IREDELL COUNTY HEALTH DEPARTMENT

IMPROVEMENT PERMIT / AUTHORIZATION TO CONSTRUCT / OPERATION PERMIT / EXISTING SYSTEM INSPECTION

System Description: LP PPBPS

SOIL/SITE EVALUATION
for ON-SITE WASTEWATER SYSTEM

AS BUILT SKETCH

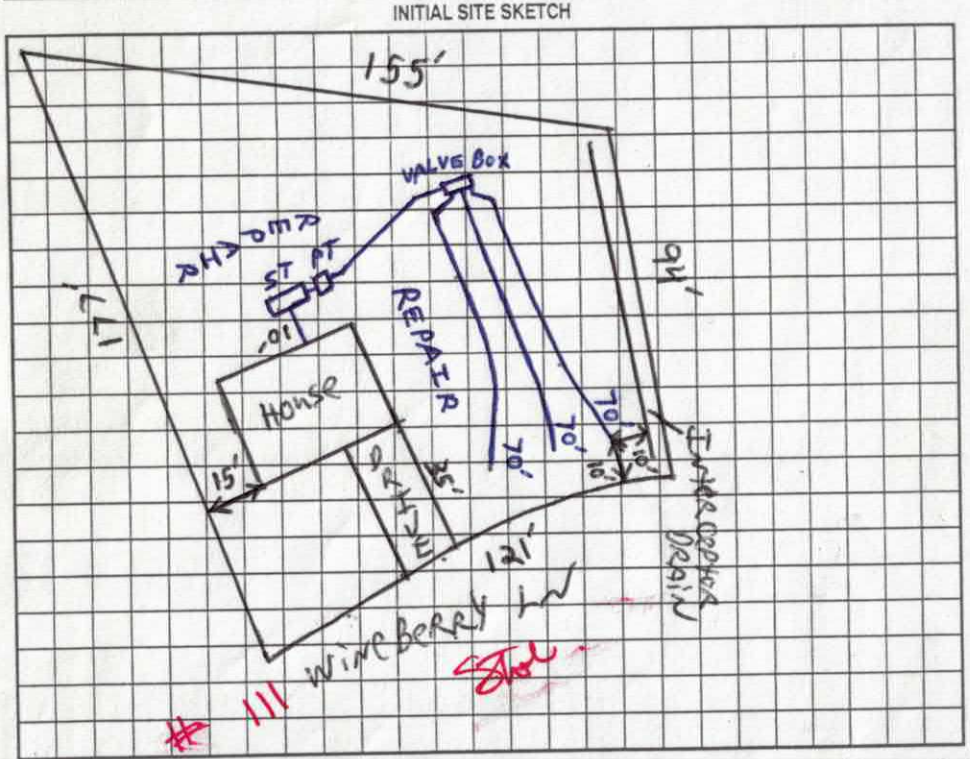
Comments/Conditions: INSTALL ON CONTOUR - MAINTAIN SETBACKS
INSTALL INTERCEPTOR DRAIN AS SHOWN

Lines installed as shown on site plan.
* Did not install interceptor drain
→ Did not have enough fall (elevation difference) to drain to surface on owner's property.
I Did not see any evidence of lateral water movement. Jim Hoggard, RS.

Show profile locations and other site features (dimensions, reference or benchmark, and North).

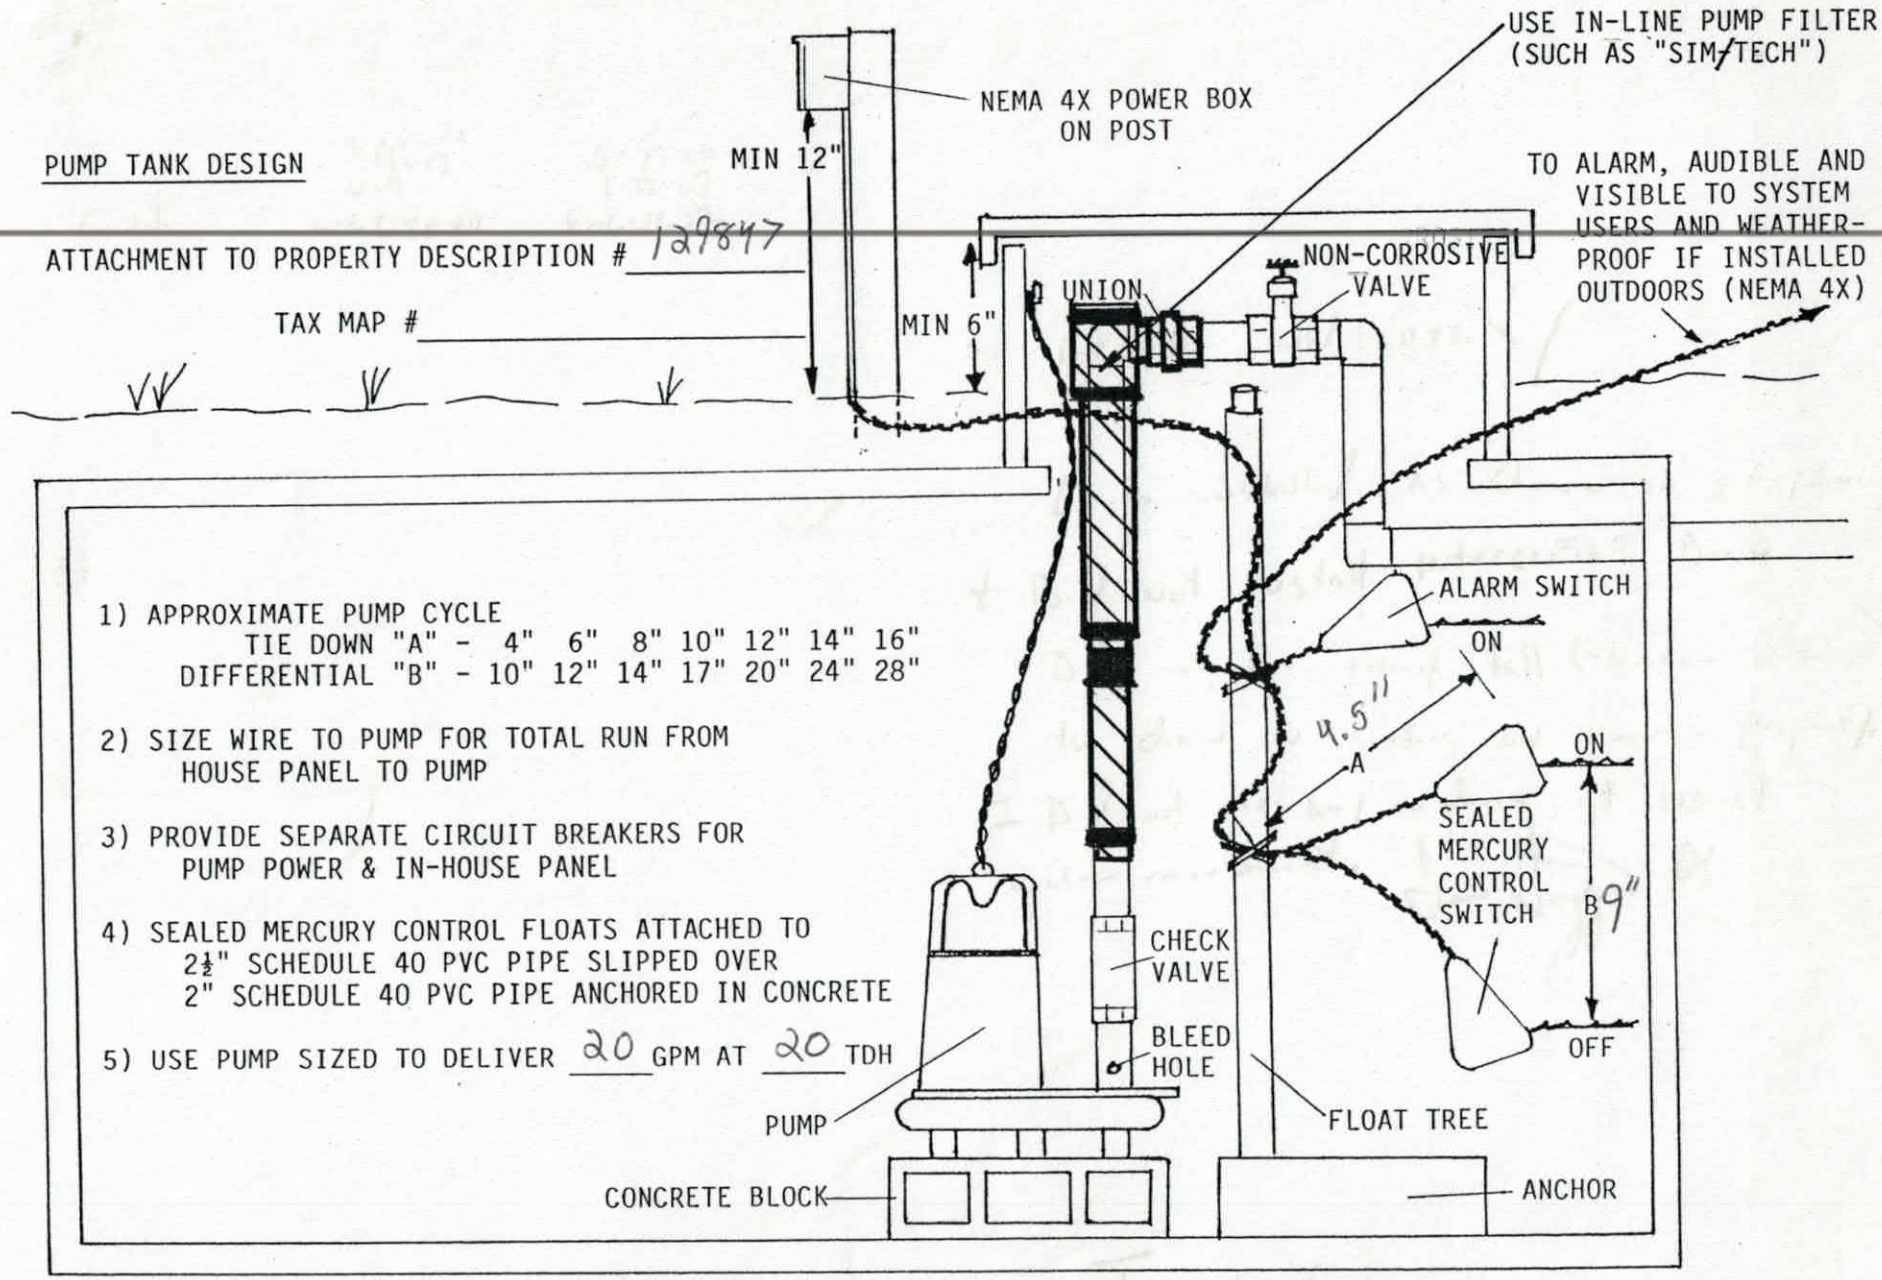
COMMENTS: Will Re-eval using Pits, Repair Exemption, and Interceptor Drain Potential

COMMENTS: NEED INTERCEPTER DRAIN
